Model: Bellini-C3		Date:05-Jul-06	No.: MB234001
Modified Article: TONER BANK CASE		Prepared by: S. Ishizu	
From: 2nd Tech. Support Sec. Service Support Dept.			
Reason for Modification:	☐ Parts catalog correction ☐ Vendor change ☐ Other ☐ To facilitate assembly ☐ To improve reliability ☒ To meet standards (RoHS compliant) ☐ Part standardization ☐ Product Safety

Model: Bellini-C3		Date: 05-Jul-06	No.: MB234002
Modified Article: Stopper Bracket		Prepared by: S. Ishizu	
From: 1st Tech. Support Sec. Service Support Dept.			
Reason for Modification:	☐ Parts catalog correction ☐ Vendor change ☐ Other ☐ To facilitate assembly ☐ To improve reliability ☒ To meet standards (RoHS compliant) ☐ Part standardization ☐ Product Safety

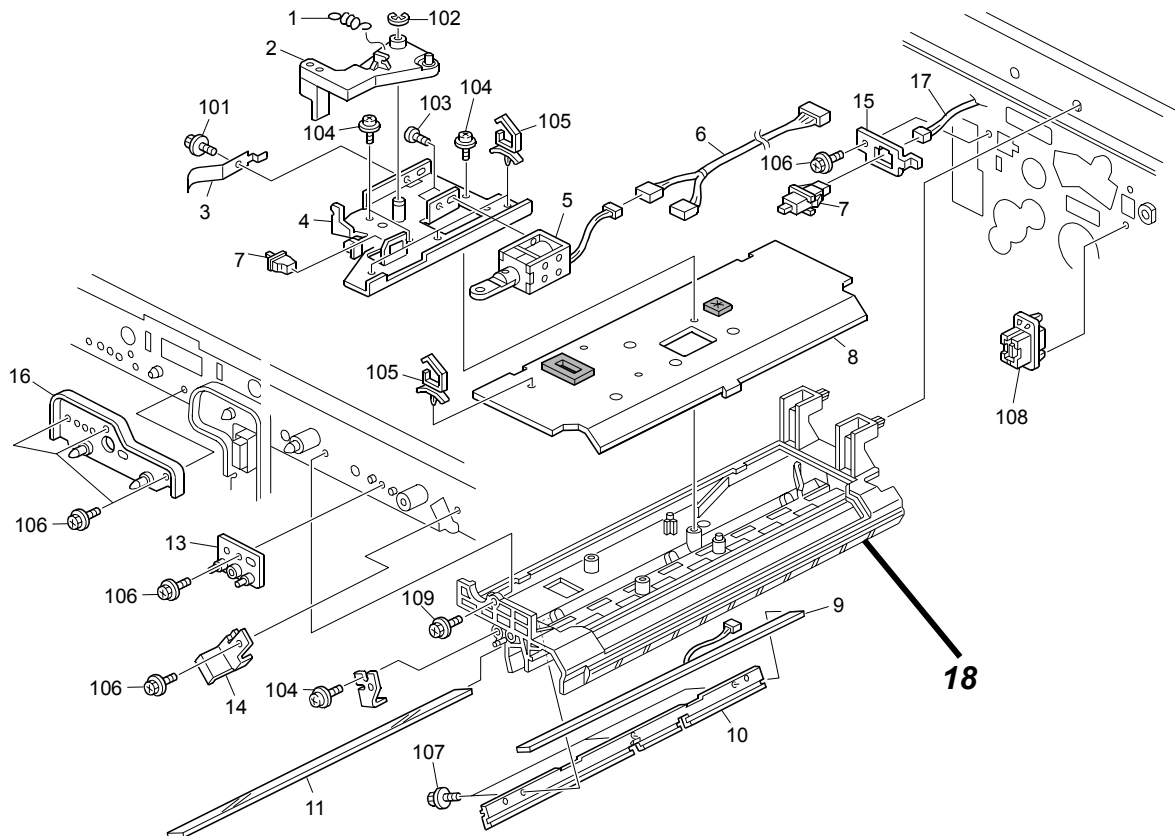
Change: The part in the table was added.

Reason: Requests were received from the field.

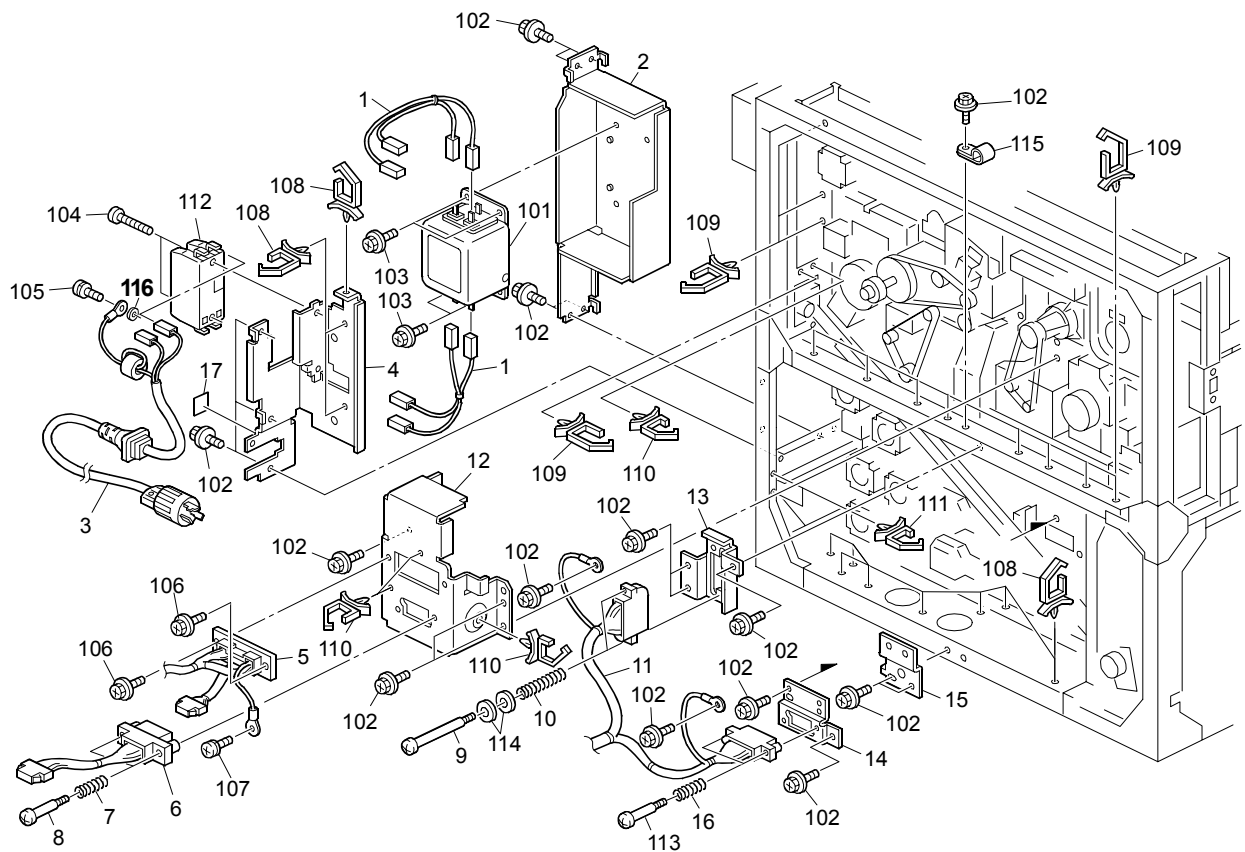
Change: The part in the table was added.

Reason: To further increase the product safety margin.

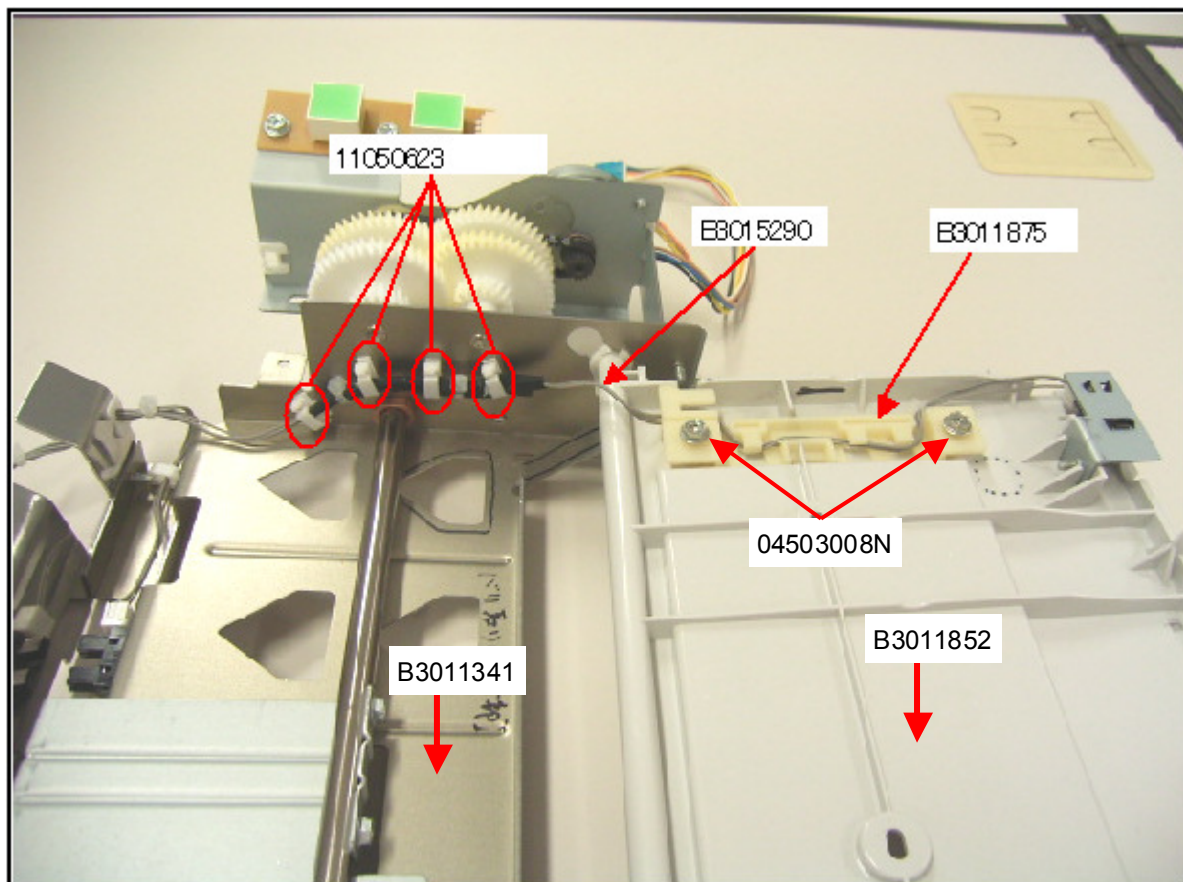
Change: The above two parts are newly added.
The length of the harness is changed.

Reason: To improve reliability.

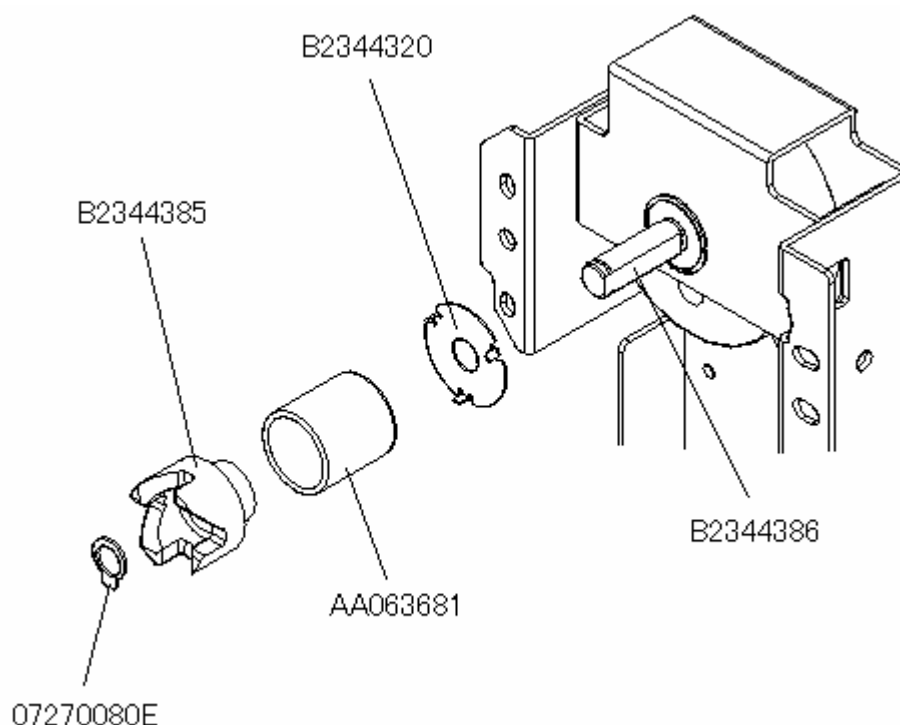
Change: Shape of the parts was modified.

Reason: To improve reliability.

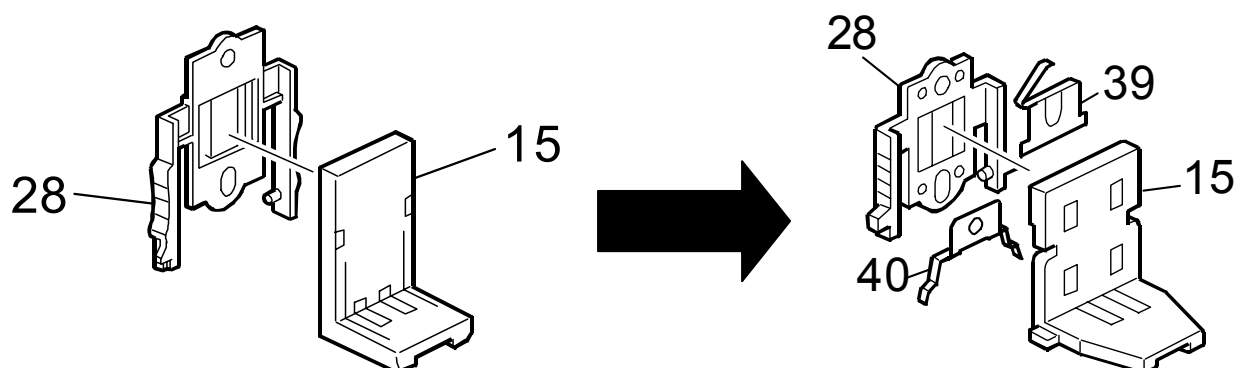
Change: Shape of the parts was modified.

Reason: Part standardization with Venus/Aegis series.

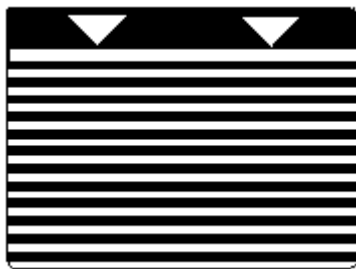
Change: Shape of the parts was modified.

Reason: To further improve the side fence durability.

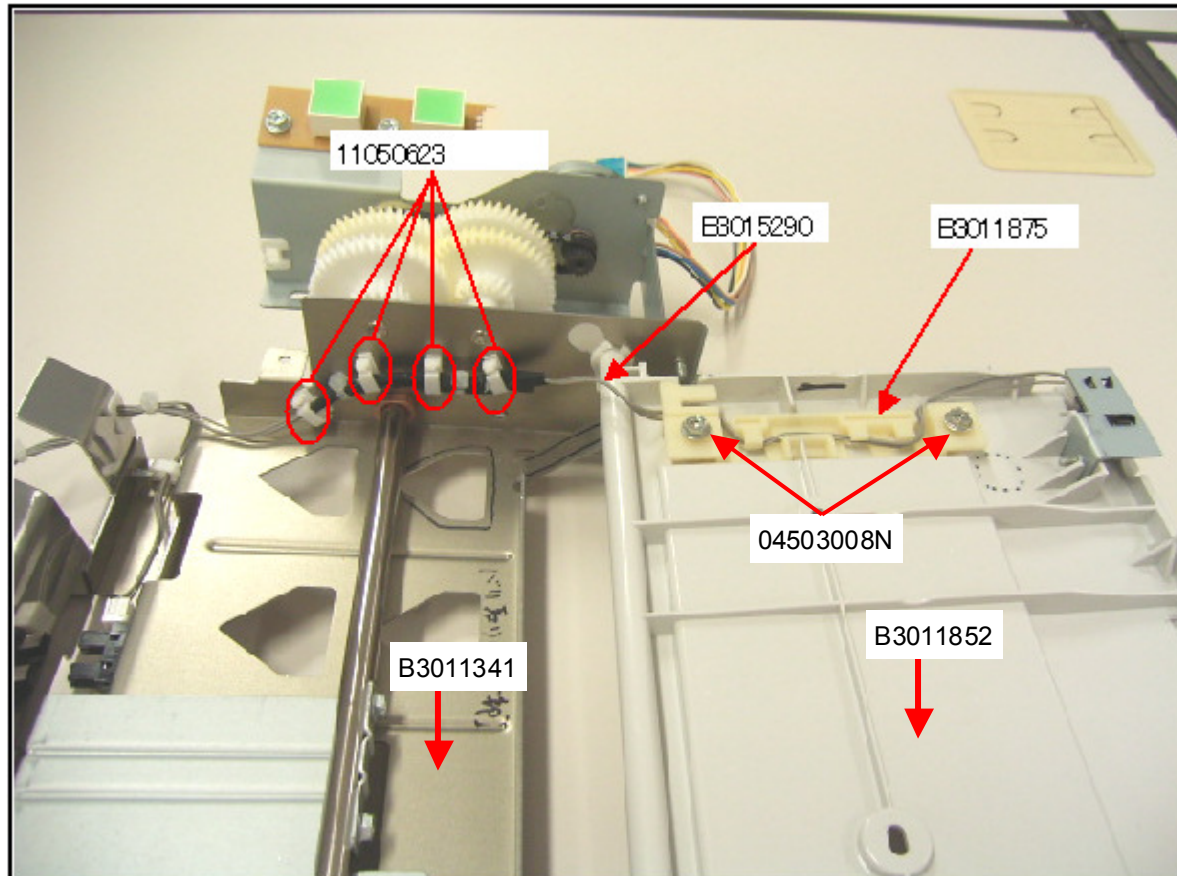
Change: The above two parts are newly added.
The length of the harness is changed.

Reason: To improve reliability.

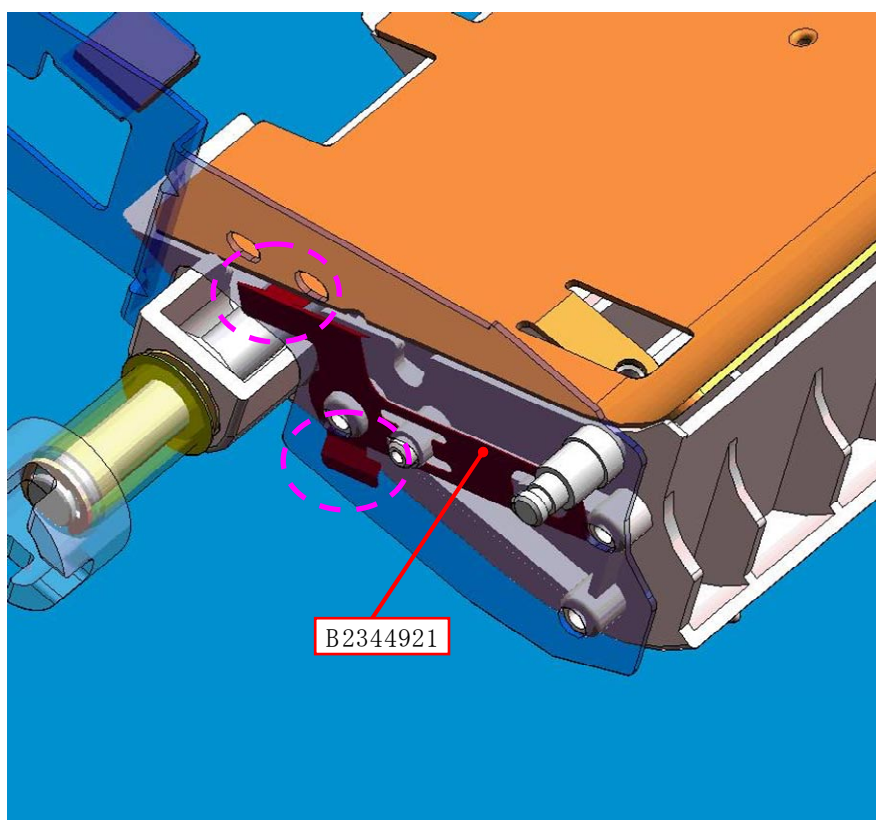
Change: An antistatic sheet and a ground plate were added.

Reason: To improve reliability.
